PLANNING REPORT

OHIO HEALTH REHABILITATION HOSPITAL DUBLIN AT 3805 EMERALD PKWY 23-057AFDP

Case Summary

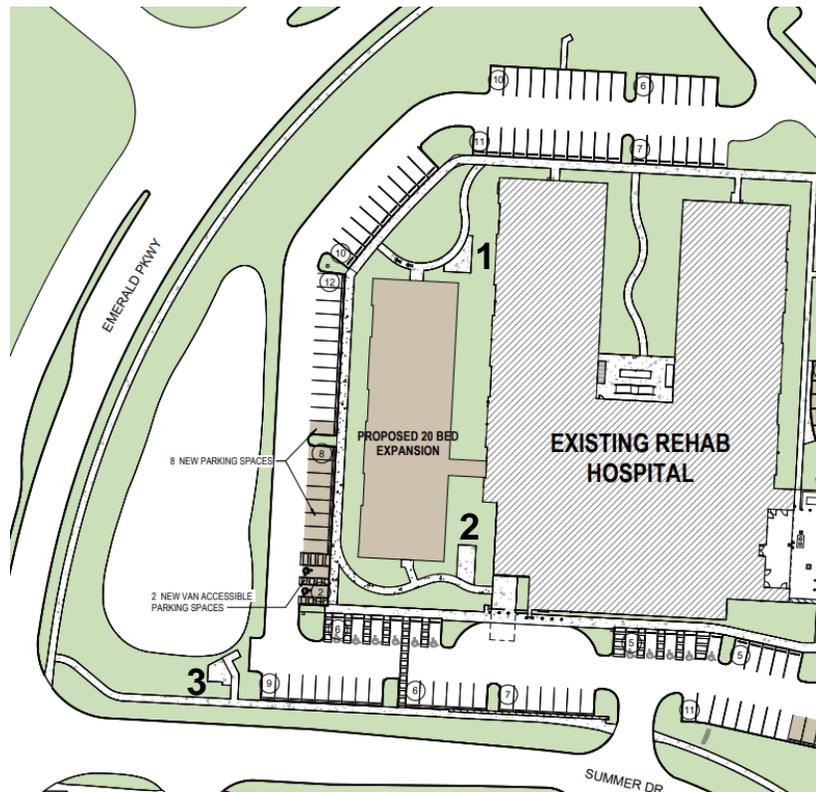
Existing conditions provide 103 parking spaces including 11 ADA spaces. The applicant is requesting 22 new parking spaces, including 2 ADA spaces, totaling 125 parking spaces.

At the related 2019 Informal Review, the applicant provided a parking study which demonstrated the facility's parking needs based on other rehabilitation hospital facilities they operate. Based on that analysis, the applicant opined that the City's minimum parking requirements were more than needed. The PZC expressed concern regarding the amount of open space that would remain once the anticipated building addition was constructed along with related parking. Later at FDP, the PZC approved a Minor Text Modification to reduce parking on site, along with a condition of approval to relocate parking spaces along the western portion of the drive aisle, adjacent to the pond, to the north of the drive aisle to create a vista to the pond.

Staff acknowledges additional parking would need to be provided for this proposed addition; however, additional parking beyond the minimum amount may not be appropriate considering past applicant and PZC discussions to reduce parking. Staff recommended the applicant remove the proposed parking east of the existing building to conserve greenspace, and encouraged the additional parking to be added near public building access. The applicant has provided a response to request additional parking, and staff is requesting the PZC's opinion on the parking request.

There are no bike parking requirements for the site; however, when new development is proposed staff recommends adding bike parking facilities to align with the future goals of the City. The Bridge Street District Code bike parking requirements provides standard practice on the appropriate amount of bike parking to provide: commercial uses have one bike space for every 10 vehicle spaces. The applicant is proposing 12 bike parking spaces in two areas of the site: east of the main hospital building adjacent to proposed vehicular parking and southeast of the addition in the patio amenity space. Staff is supportive of the proposed bike parking locations.
